P-7799-2 24791

NAME	DATE
(JINDAL)	$JINDAL \ ALUMINIUM \ LTD.$	DRAWN	J.P.KAUSHIK	24-12-2010
SYMBOL OF QUALITY	BANGALORE-560073 (INDIA)	CHECKED		
AN ISO 9001 COMPANY	BANGALORE - 300073 (INDIA)	APPROVED	S.S.GARG	19-01-2011
ALL DIMENSIONS ARE IN mm. ROUND OFF ALL SHARP CORNERS WITH 0.40 mm. TOLERANCES WILL BE AS PER IS:6477-1983 UNLESS OTHERWISE SPECIFIED		SCALE		1:1
		AREA mm ²		1520.674
		PERIMETER mm.		439.85
PARTY'S NAME	, , , , , , , , , , , , , , , , , , , ,	WEIGHT kg/m		4.106
	COIMBATORE	DRAWING	No. S	ECTION No.
PARTY'S DRAWING No.	AS PER DRAWING & AS PER CUSTOMER REQUIREMENT	P-779	99-2 -	_
		24791	247	91(ISSUE-3)
ALLOY & TEMPER	HE9 WP			
DESCRIPTION	TEXTILE M/C RY SECTION

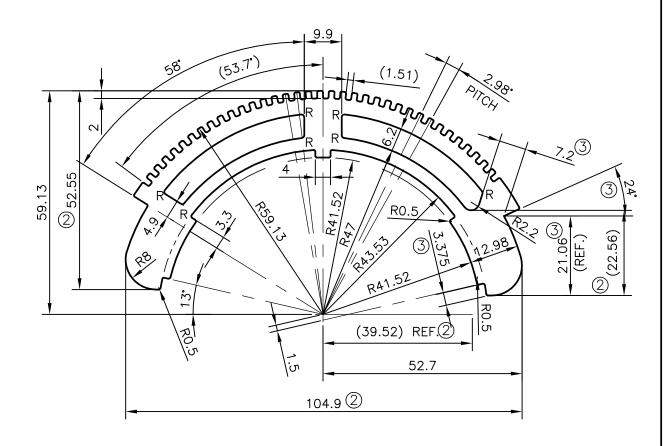
ISSUE-2 R = R0.75 mm (7 PLACES)

DIMENSION CHANGED FROM 37 TO 39.52,104 TO 104.90, 4.9 TO 7.3, 20.36 TO 22.56 & 51.95 TO 52.55.

WEIGHT ALSO CHANGED FROM 3.940 kg/M TO 4.071 kg/M

DIMENSION CHANGED FROM 7.3 TO 7.2 mm & ANGLE CHANGED FROM 72° TO 24° DIMENSION CHANGED FROM 4.975 mm TO 3.375 mm DIMENSIONS ADDED 21.06 (REF.) WEIGHT ALSO CHANGED FROM 4.071 kg/M TO 4.106 kg/M
